MEMORANDUM

TO: District of Columbia Board of Zoning Adjustment
FROM: Anne Fothergill, Case Manager
JL Joel Lawson, Associate Director Development Review
DATE: July 14, 2015
SUBJECT: BZA Case 19035, 1325 D St S.E., Buchanan School site

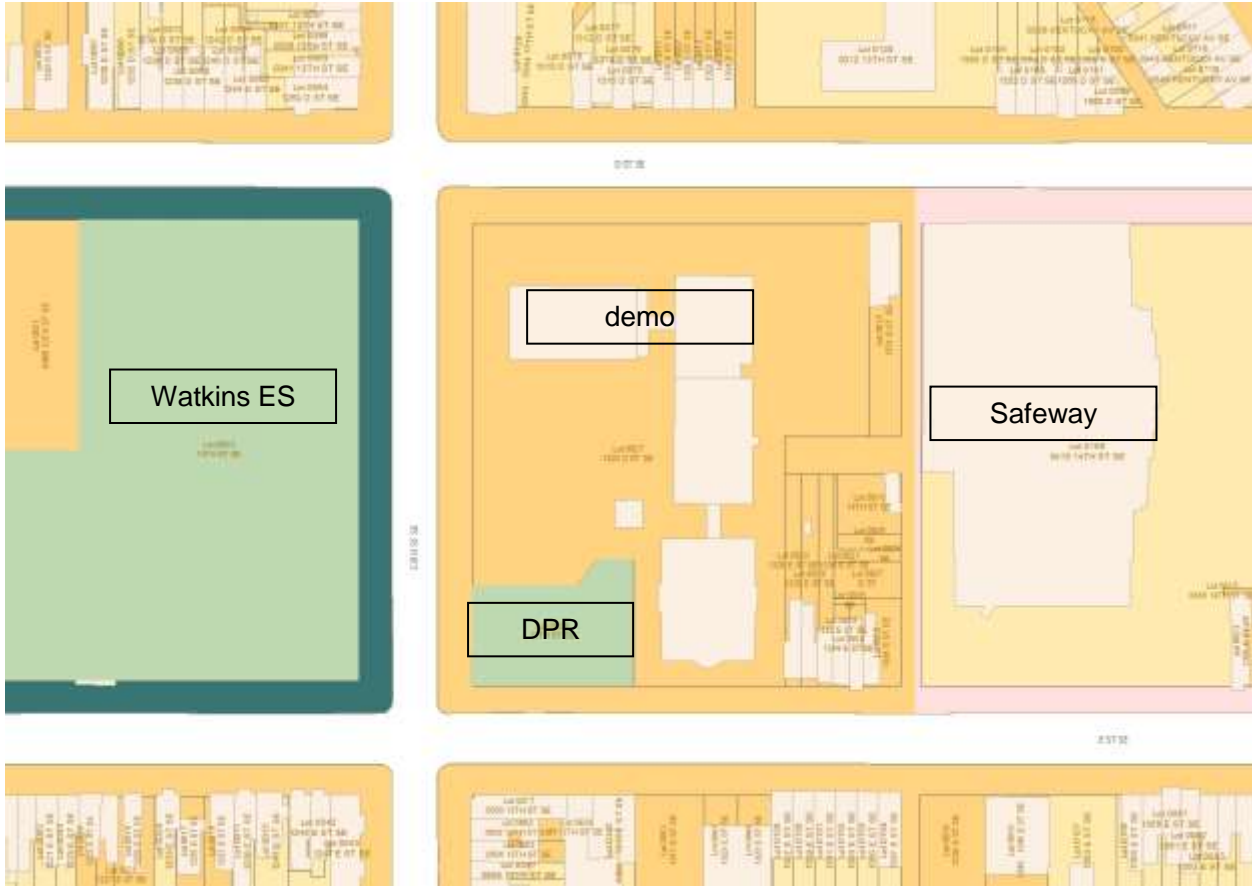
As part of an overall larger development plan, the applicants plan to parcel off the side and rear yards of the historic former Buchanan School, which fronts E Street SE.¹ They would remove two non-historic wings of the school and create new buildable lots that would front 13th Street SE and D Street SE. On Parcel A, which is the west side of the subject property, the applicants propose 22 single-family townhouses and six flats. They are proposing 17 new lots - 5 lots along D Street and 12 lots on 13th Street. As shown in the applicant’s submission, the 1903 map shows that historically there were lots along 13th and D Streets (Exhibit 31A).

excerpted from applicant's submission (Exhibit 31D1, Sheet A006)

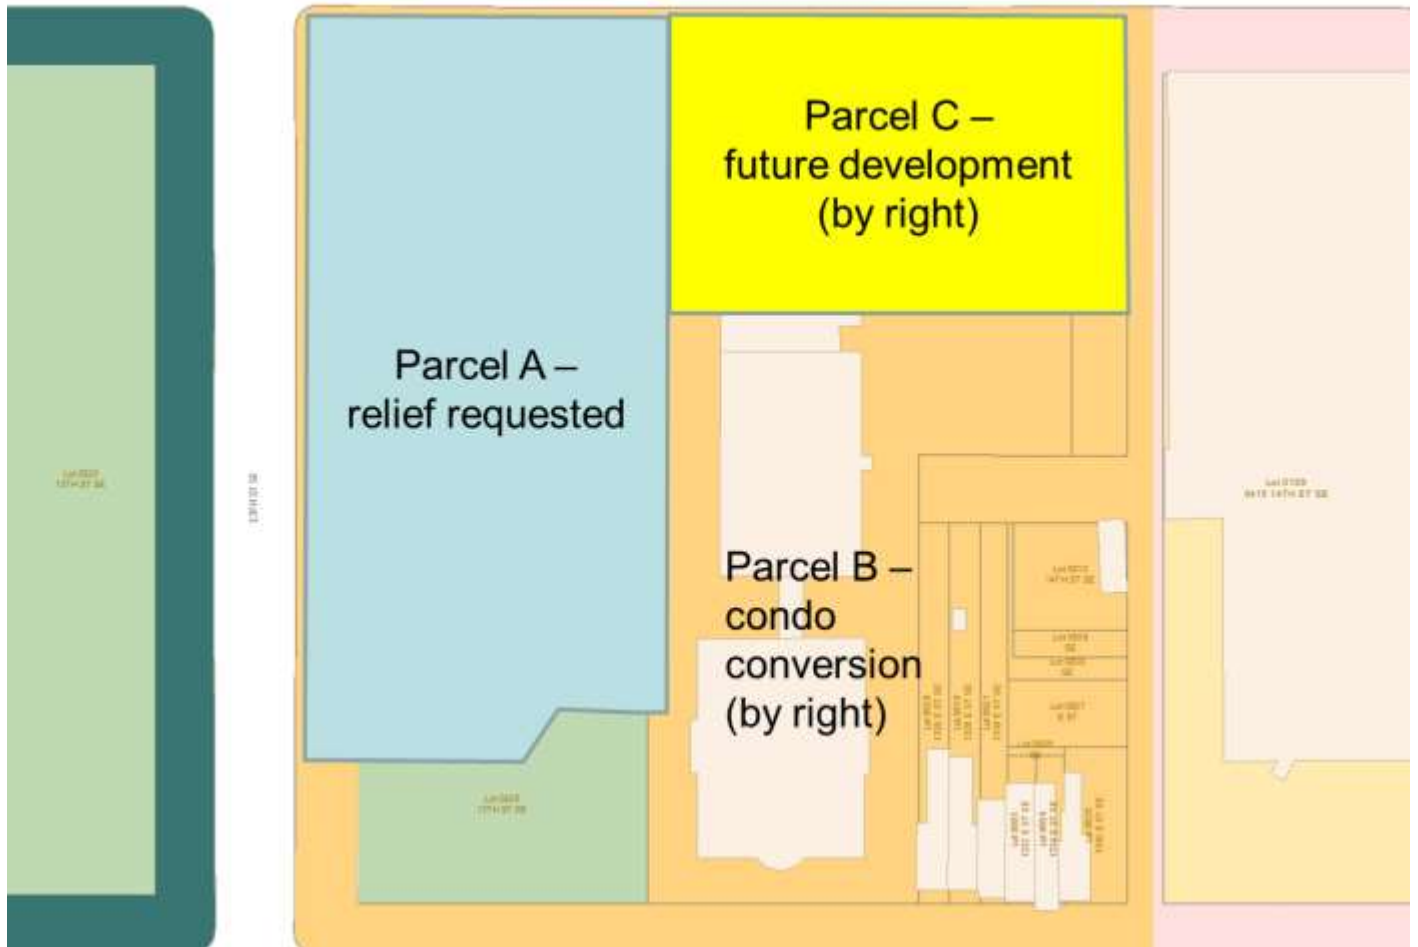
In the future the applicants plan additional residential development on the subject property. On Parcel B they plan to convert the former school building into residential units and on Parcel C they plan to construct matter-of-right townhomes on new lots fronting D Street in the rear yard of the former school building (see Sheet A006 in Exhibit 31D1). This development would conform to zoning.
